<b>Well Name:</b> BIG EDDY UNIT DI 30 WEST 15-17	<b>Well Location:</b> T20S / R31E / SEC 15 / NESE / 32.570288 / -103.848941	<b>County or Parish/State:</b> EDDY / NM
<b>Well Number:</b> 2H	<b>Type of Well:</b> OIL WELL	<b>Allottee or Tribe Name:</b>
<b>Lease Number:</b> NMLC063667	<b>Unit or CA Name:</b> BIG EDDY	<b>Unit or CA Number:</b> NMNM68294X
<b>US Well Number:</b>	<b>Operator:</b> XTO PERMIAN OPERATING LLC

**Type of Submission:** Notice of Intent

**Type of Action:** APD Change

BIG EDDY UNIT DI 30 West 15-17 2H  
APD ID# 10400097384  
SUNDRY LANGUAGE

[Figure E] 4 String – Uncemented Annulus between 2<sup>nd</sup> Intermediate and Production Casing Strings. (Reference R-111-Q: Exhibit B)

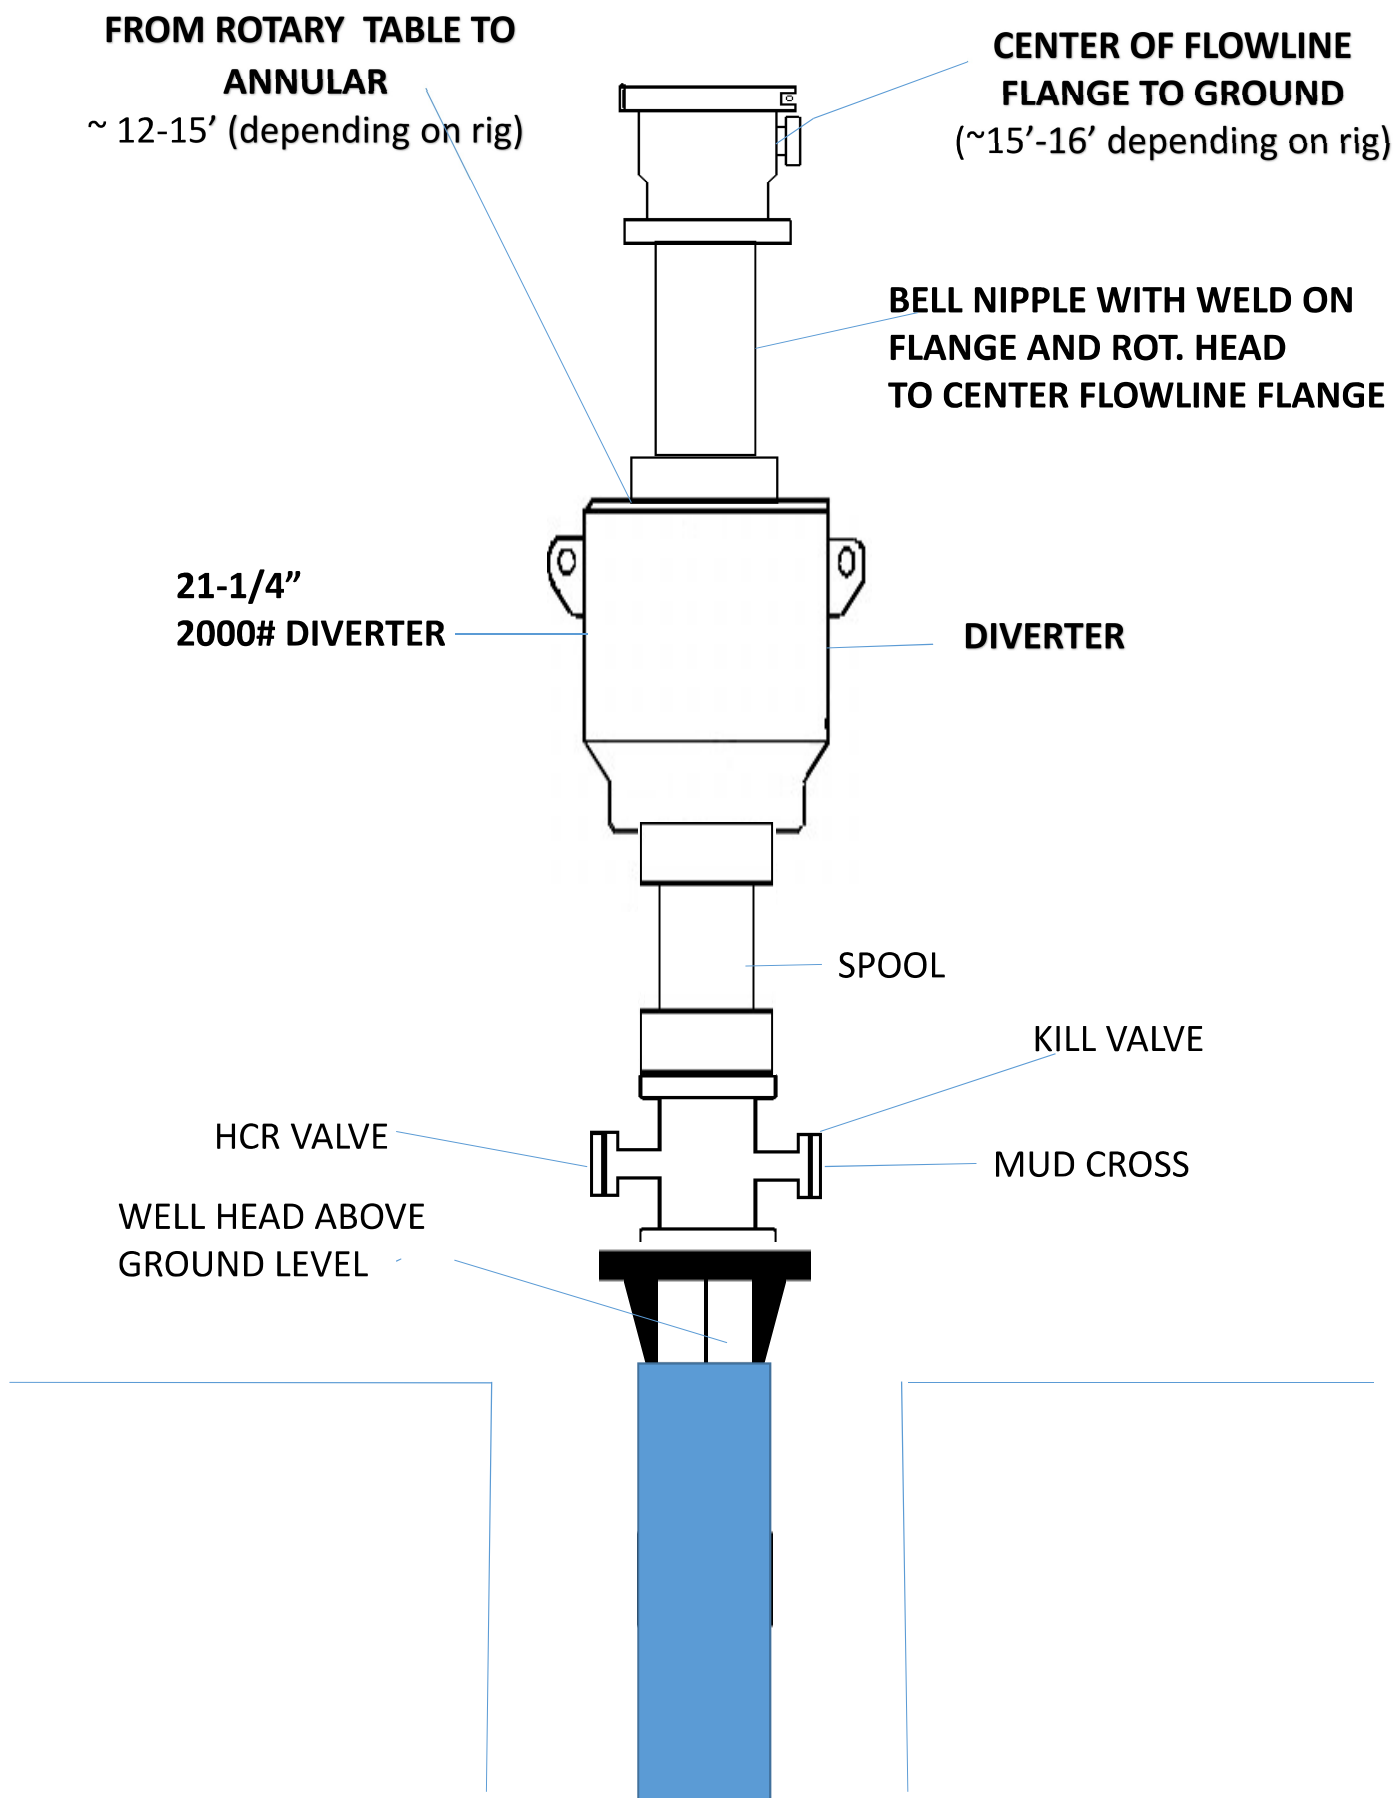
- Casing design to be changed from the proposed 4-string engineered weak point design to a 4-string design with an uncemented annulus between 2nd intermediate and production casing strings
- Associated changes required in the cement program & the mud circulation system as per the newly proposed casing design mentioned above

Open 2nd intermediate x production annulus to monitor during completion. In the event of production casing failure, pressure will either release at surface or into the formation below 2nd intermediate shoe in the Delaware Mountain group / Brushy Canyon relief zone (R111Q Figure E)

- Alignment with KPLA requirements per schematic below, with open 2<sup>nd</sup> Int x production casing design and utilizing new casing that meets API standards.

- Cement should tie-back **500 feet** into the previous casing but not higher than the **Delaware Group. Operator must verify top of cement per R-111-Q requirements.** Submit results to the BLM. Operator shall provide method of verification.

# TEST REPORT

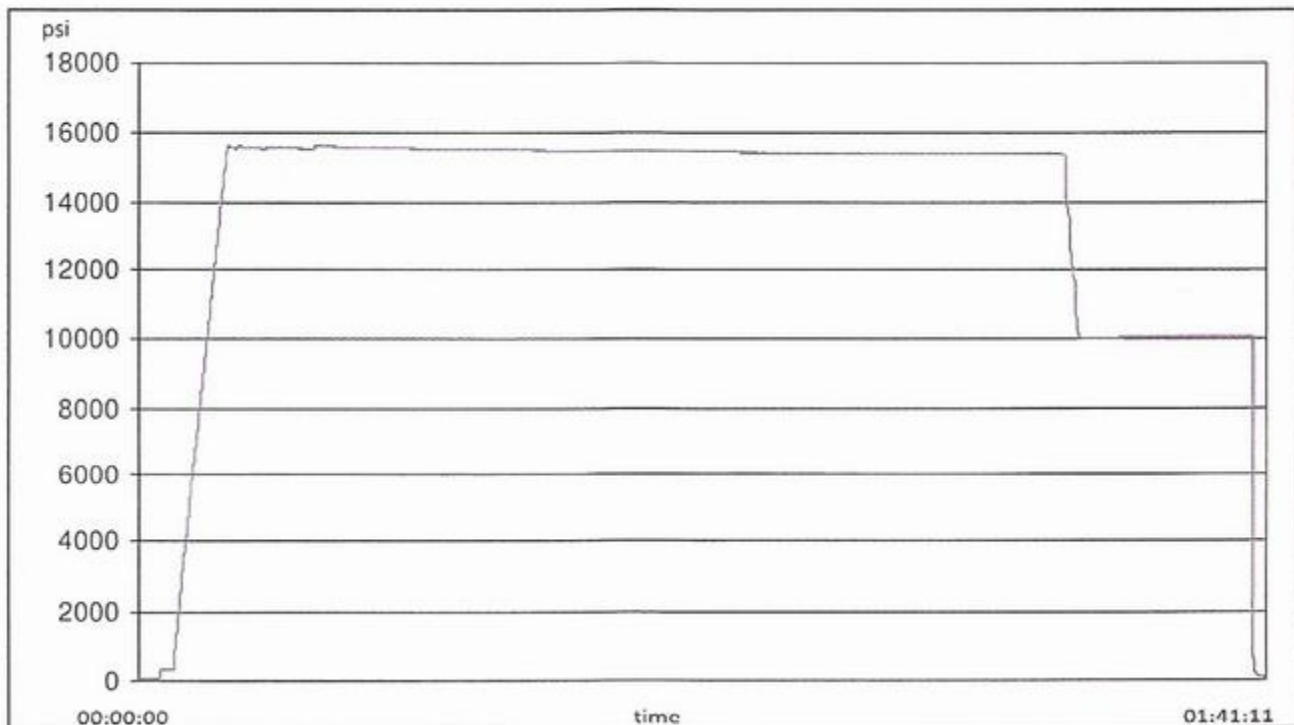
A variance is requested to allow use of a flex hose as the choke line from the BOP to the Choke Manifold. If this hose is used, a copy of the manufacturer's certification and pressure test chart will be kept on the rig. Attached is an example of a certification and pressure test chart. The manufacturer does not require anchors.

1. Variance approved to use flex line from BOP to choke manifold. Manufacturer's specification to be readily available. No external damage to flex line. Flex line to be installed as straight as possible (no hard bends).
